Subject: AL/20/21/PL - Wings Nursery, Lindsey Road, Woodgate

Mark Warwick
Tree Officer, Greenspace Team

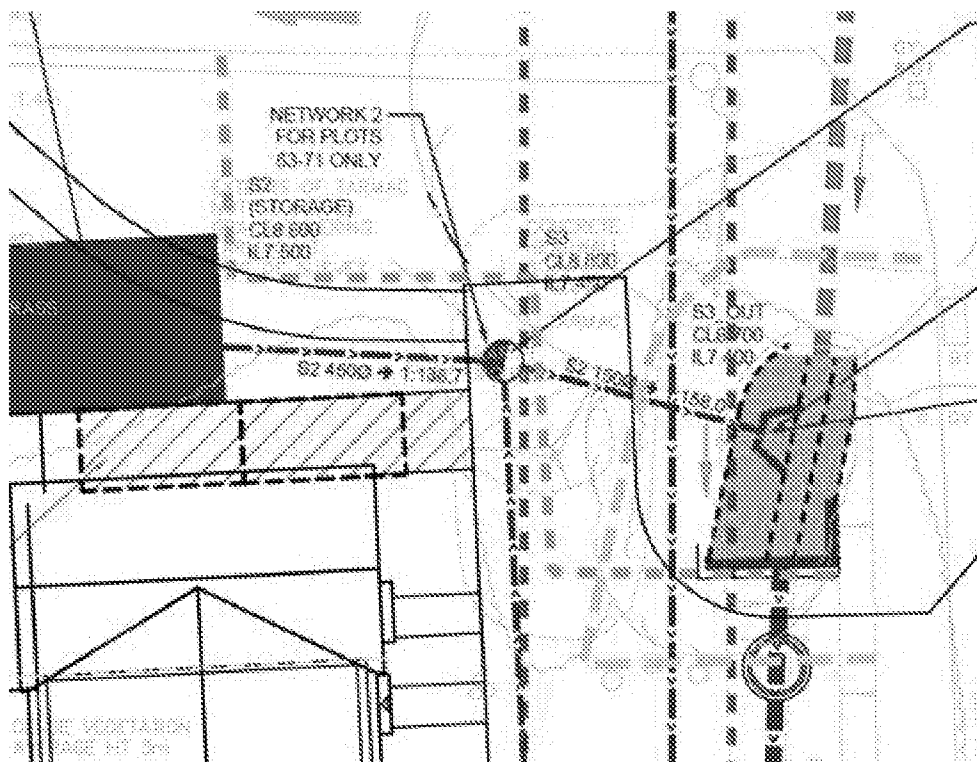
Q. Please can you confirm that the tree illustrations on the attached drainage plan represent either Root Protection Area or Crown Spread.

Proposed outfall routing in proximity to T1 appears to be well within the RPA of that tree, and we still do not have a plan showing the precise extent of incursion. I will need to see the RPA of T1 shown in relation to the proposed utility apparatus before considering that concession. In any event, there needs to be overriding justification for RPA incursion – can your client's drainage engineer not present an alternative option?

The drainage plan shows the drain being routed through the Construction Exclusion (Root Protection Zone?) although potentially outside of the RPA of T15? Again, we need the RPA of T15 shown on the drainage plan and a CEZ to complement (including the 2m buffer).

Also attached is a copy of the drainage layout which shows drainage runs positioned outside RPAs of all retained trees bar a short section linking with the existing culvert to the south of T1 (below).

Arboricultural supervision will determine whether a hand dug trench or broken trench within the RPA is acceptable or whether a trenchless approach has to be adopted.
